From:	Pederson Ronda M (AREVA NP INC) [Ronda.Pederson@areva.com]
Sent:	Thursday, October 16, 2008 2:58 PM
То:	Getachew Tesfaye
Cc:	DELANO Karen V (AREVA NP INC); WELLS Russell D (AREVA NP INC); KOWALSKI David
	J (AREVA NP INC); BENNETT Kathy A (OFR) (AREVA NP INC)
Subject:	Response to U.S. EPR Design Certification Application RAI No. 44, FSAR Ch 10,
	Supplement 1
Attachments:	RAI 44 Supplement 1 Response US EPR DC.pdf

Request for Additional Information No. 44, Supplement 1 Revision 0

U. S. EPR Standard Design Certification AREVA NP Inc. Docket No. 52-020 SRP Section: 10.03.06 - Steam and Feedwater System Materials Application Section: 10.3.6 CIB1 Branch

10.03.06-1

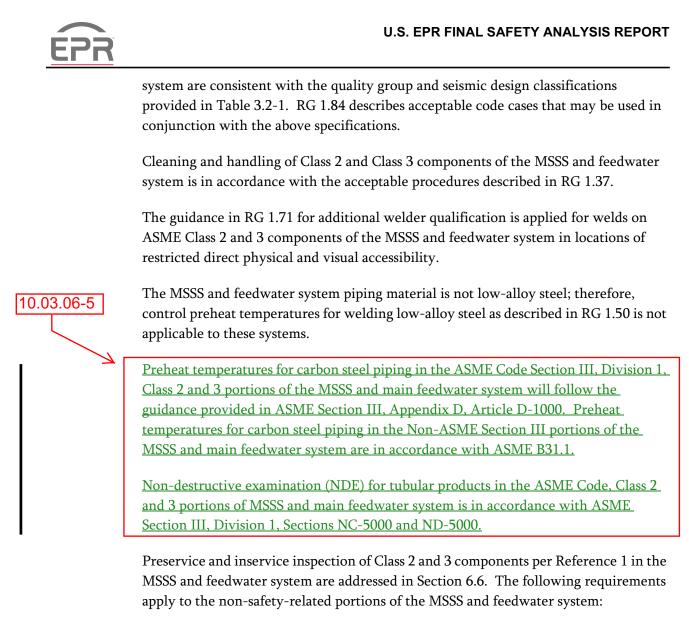
FSAR Tier 2, Table 10.3-11 lists material specifications and grades for ASME Code, Class 2 and 3 MS and FW piping and non-code piping. The applicant did not however include material specifications and grades for components such as valves and fittings. In addition, the applicant did not list weld filler material specifications and classifications. In order for the staff to determine that MS and FW systems materials meet the requirements of GDC 1 and 10 CFR 50.55a, the staff requests that the applicant modify Table 10.3-11 to include material specifications and grades for components such as valves and fittings used in the ASME Code Class 2 and 3 portions of the MS and FW systems. The staff also requests that the applicant provide weld filler material specifications and classifications that will be used in the ASME Code Class 2 and 3 portions of the MS and FW systems.

FSAR Tier 2, Section 10.3.6.3 states that MSSS and feedwater system piping material is flow accelerated corrosion (FAC) resistant, unless the application is specially evaluated and found to be non-susceptible to FAC. The applicant indicates that piping material resistant to FAC is constructed of carbon steel which contains a minimum of 0.10 percent chromium. Given that the material specifications listed in Table 10.3-11 do not contain minimum chromium content requirements, the staff requests that the applicant provide a note to Table 10.3-11 to indicate the aforementioned requirement for minimum chromium content for components that the applicant has determined are susceptible to FAC. In addition, the staff requests that the applicant provide a basis for its determination that carbon steel piping containing a minimum of 0.10 percent chromium is FAC resistant.

U.S. EPR FSAR Tier 2, Table 10.3-11—Main Steam Supply System and Main Feedwater System Material Data, will be modified to include material specifications and grades for piping, fittings and valves.

The material specifications for piping, fittings and weld filler metals in systems found to be susceptible to flow accelerated corrosion (FAC) will include a requirement for minimum chromium content of 0.10 percent. A note will be added to U.S. EPR FSAR Tier 2, Table 10.3-11—Main Steam Supply System and Main Feedwater System Material Data, to specify this requirement.

Table 10.3-11 — Main Steam and Main Feedwater Piping Material DataMain SteamSupply System and Main Feedwater System Material DataTable 10.3-11—Main SteamSupply System and Main Feedwater System Material Data, provides material data forthe MSSS and main feedwater system - piping.The MSSS and main feedwater systemdo not use copper or copper alloy materials.
